HISTORIC LANDMARK COMMISSION STAFF REPORT

Everest Builders, New Construction, 470-06-56,
located at 256, 262 and 268 South 700 East and 673
and 695 East 300 South Street
in the Central City Historic District
July 2, 2008

The applicant requests approval to construct thirteen new single-family attached residential dwelling units and rehabilitate one contributing multi-family residential building with six units in the Central city Historic District. The subject property is zoned RMF-45, Moderate/High Density Multi Family Residential.

Attachment C
Site Plan and Elevation Drawings

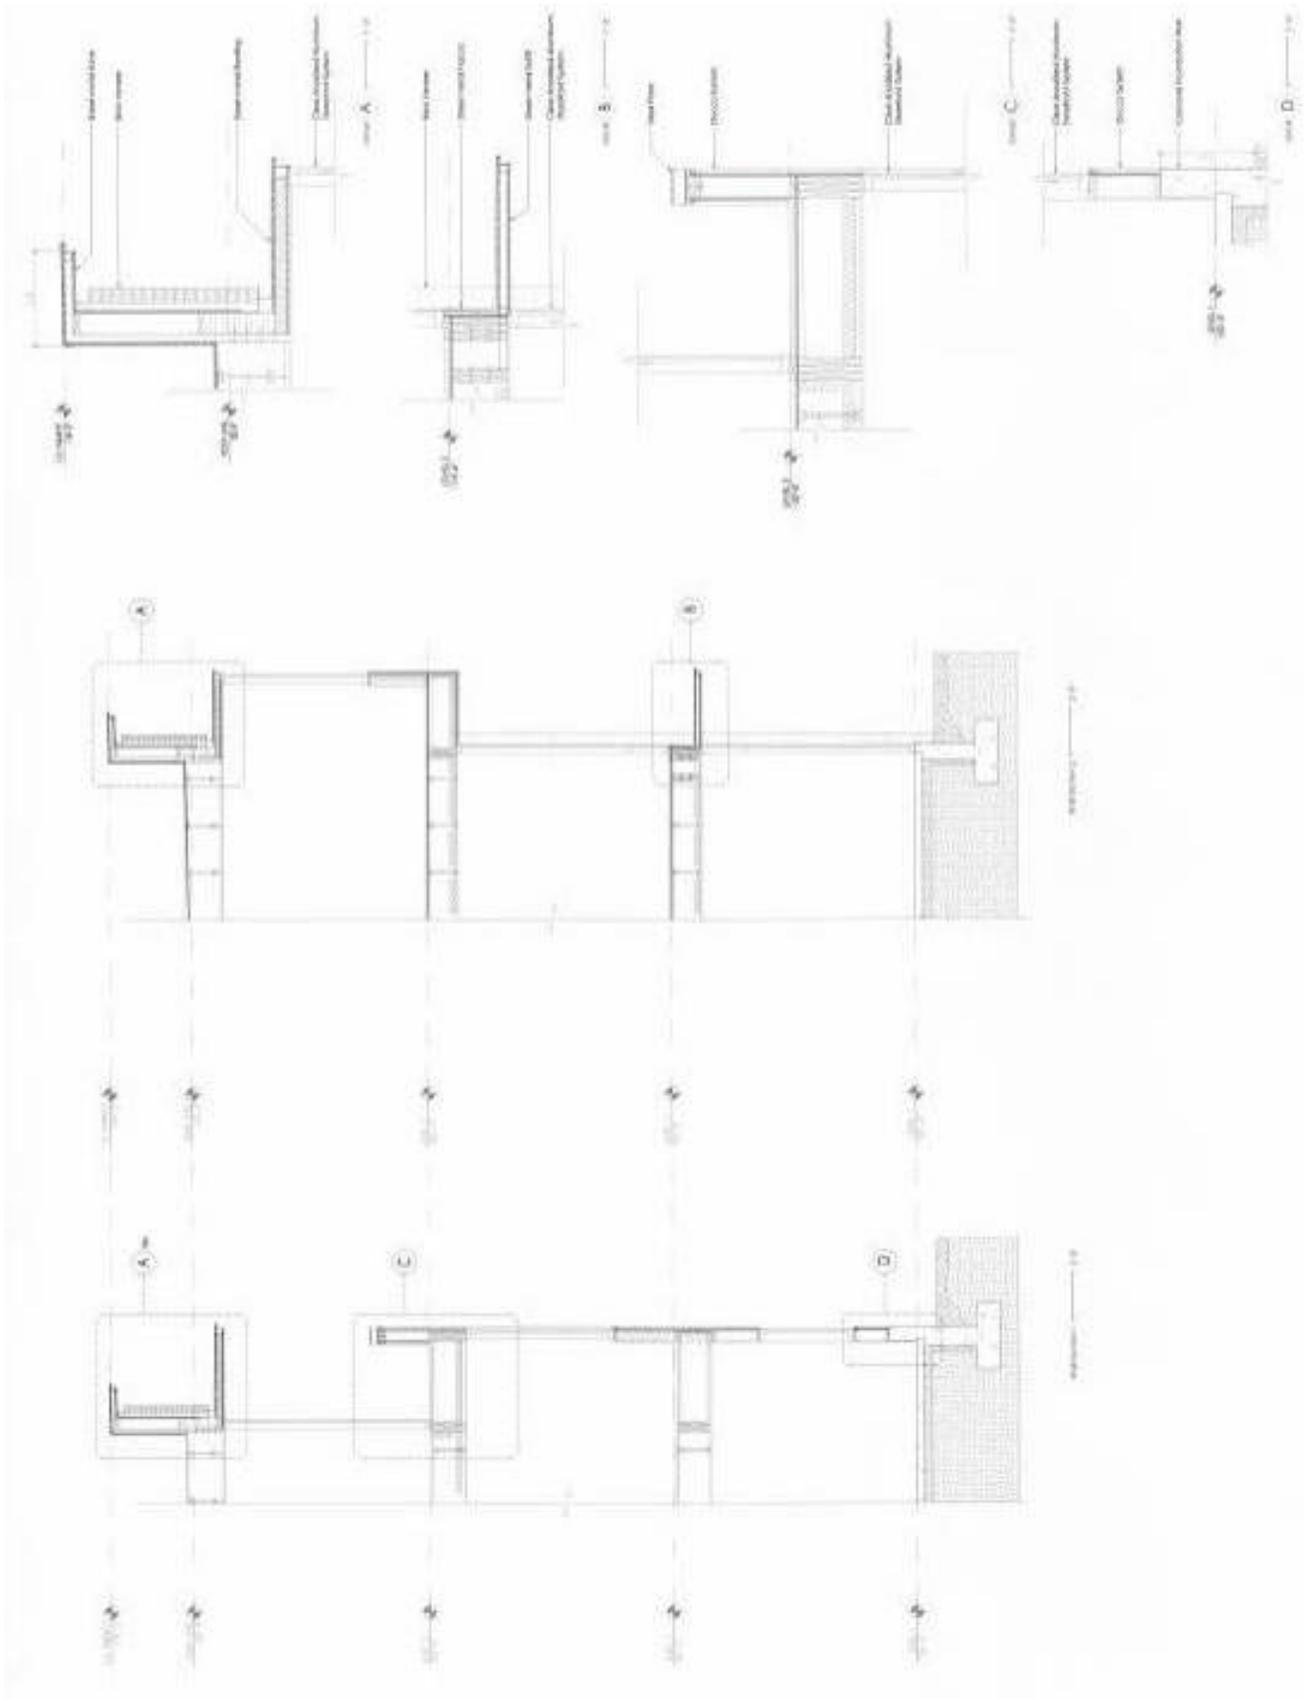
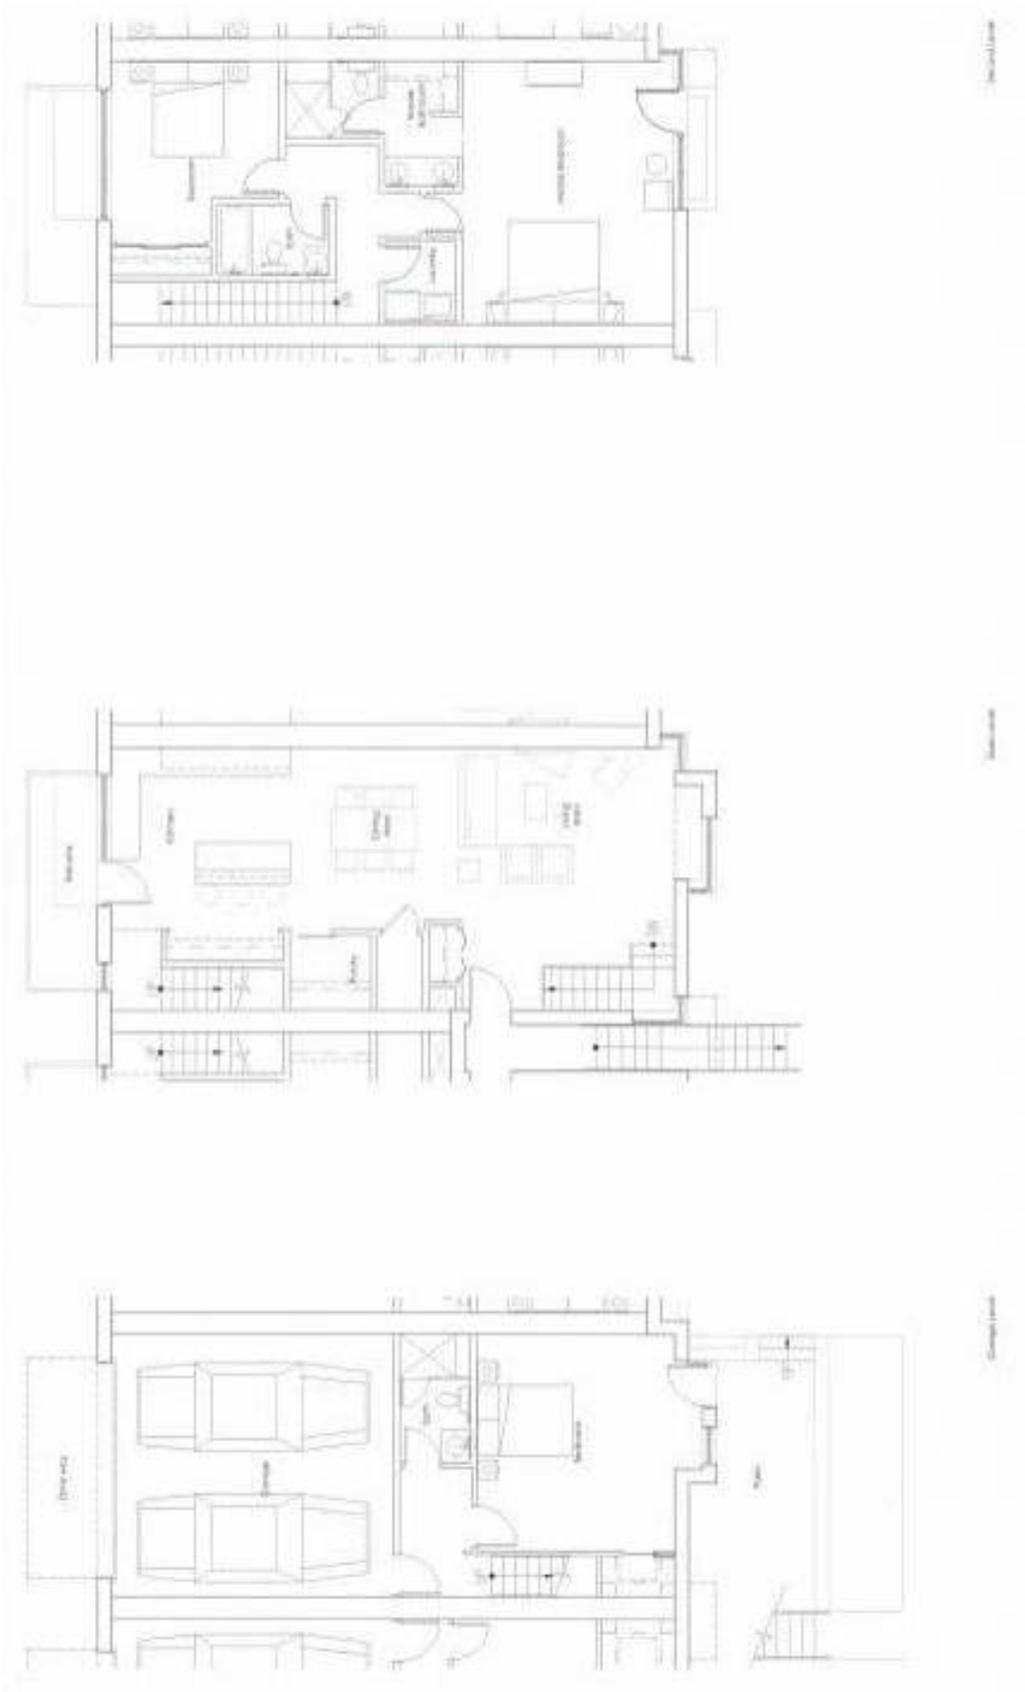
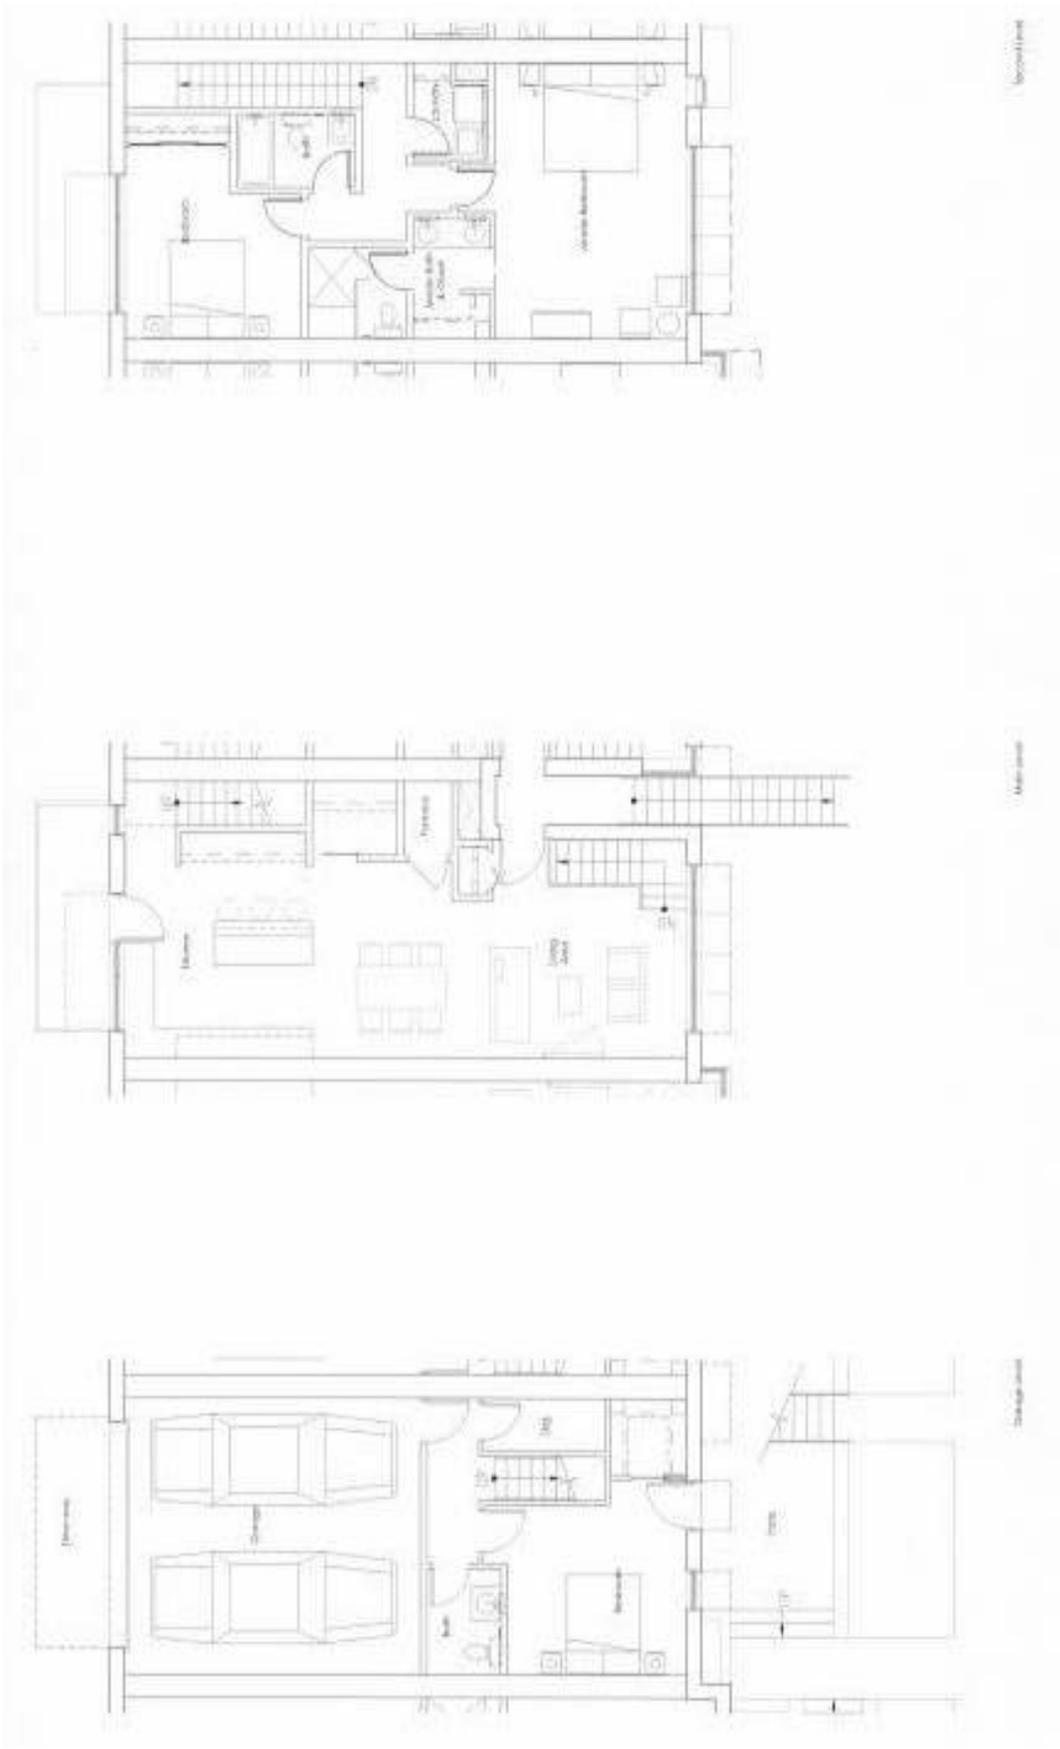
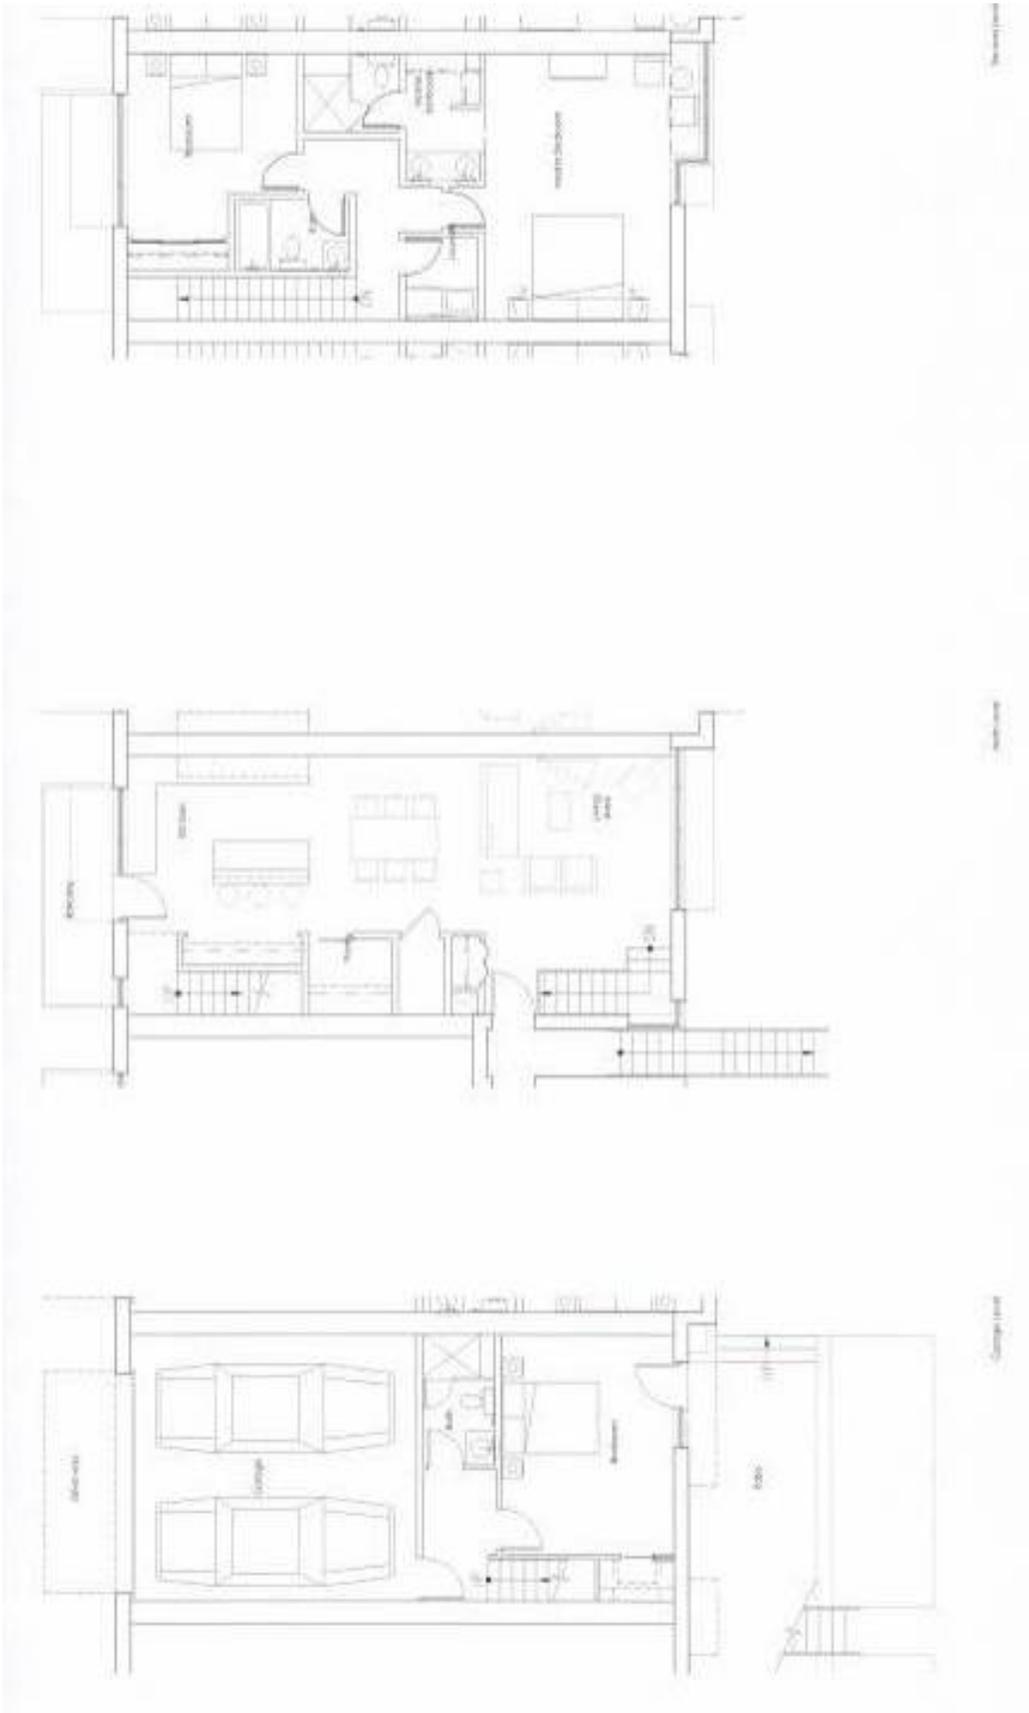
Discussion: The design of the main façade includes second story recessed porches and third story projecting stucco and glass bays. Main entrances for every other unit is up a flight of stairs and located on either side of a recessed common area. A one-story element, such as a porch, is not included in the design. The foundation is two foot (2') high concrete and the cornice is defined by a sheet metal overhang. The windows have a storefront design and are made of clear glass and anodized aluminum.

The two buildings are much wider than historic buildings in the neighborhood. The proposed building facing 700 East is approximately one hundred and ninety-feet (190') wide and the one facing Markea is approximately eight feet (80') wide. However the massing of the two new structures is visually broken up into bays with varied setbacks. The average width of existing buildings on 300 South and Markea Avenue is approximately thirty-two (32') feet wide. The width of the new building facing 300 South is approximately sixty feet (60') wide. The width of each module in the proposed new buildings facing 700 East and Markea Avenue are approximately twenty feet (20') wide. The rectangular form of the buildings is in keeping with several historic multi-family rectangular buildings on 300 South. The rooflines are flat and similar to historic apartment buildings in the district.

Discussion: There are multiple principle facades since the project faces 700 East, 300 South and Markea Avenue. The 700 East façade includes large windows pushed to the corners of each module with off-center balconies and recessed entrances. The elevation facing Markea Avenue is a large expanse of brick and stucco with thin tall windows. The elevation facing 300 South includes a two-car garage entrance. Thin projections of sheet metal define the cornice lines and serve as awnings over windows and doors. The main siding materials are brick and stucco with a concrete foundation, sheet metal overhangs, steel open railings, and clear glass and anodized aluminum windows.

The ordinance and design guidelines require preservation of the district's street plan and the directional expression of principle facades and requires the maintenance of secondary streets. Since this project faces 300 South, 700 East and Markea Avenue, it has three principle facades. Originally Markea Avenue was a private alley that developed into a mid-block street sometime between 1898 and 1911. Please see Sanborn attachment B. Even as an alleyway, there were already houses oriented towards this street. The design of the project facing Markea is mostly a blank wall and is not the design of a principle façade. Likewise the façade facing 300 South does not read as a primary façade because of the two-bay garage.

- Primary façade designs for 300 South and Markea Avenue
- A date stone be added to the foundation;
- Unit 1 be decreased in size to allow for a rear loading garage and a second entrance to the complex;
- Design that provides symmetry to each module, attention to the rhythm of solids to voids in nearby historic structures, and a one-story element that may also help to define the main entrances;

- Design and location of mechanicals and service areas; and
- Additional information on the dimensions, design and materials of railings, windows, doors, garage doors and any ornamental elements.

1898 Sanborn

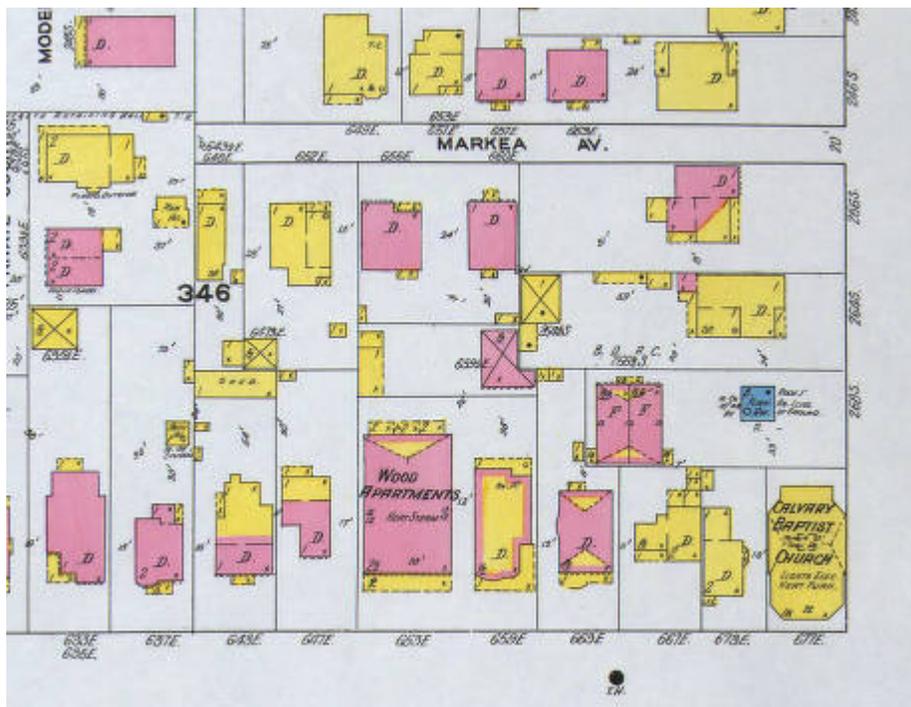
Discussion: The ordinance and design guidelines require preservation of the district's street plan. Originally Markea Avenue was a private alley that developed into a mid-block street sometime between 1898 and 1911. Please see Sanborn maps that follow. Even as an alleyway, there were already houses oriented towards this street. In keeping with the original development of the area and the initial plan submitted the applicant, staff recommends that there be no on-street parking on Markea Avenue. All parking should be interior.

Staff recommends extending the unit at the corner of 300 South and 700 East so that there is enough room for access to a two bay garage from the interior, thereby removing the garage that currently faces 300 South. Staff does not believe that this alteration would significantly change the original site plan already conceptually approved by the HLC.

The submerged court that fronts the new structures and the walkway that parallels 700 East is inappropriate for the district. Staff recommends that the size of the court be decreased, especially at the corners. The walkway for each unit should travel from the main entrance directly to the sidewalk, as seen elsewhere in the district.
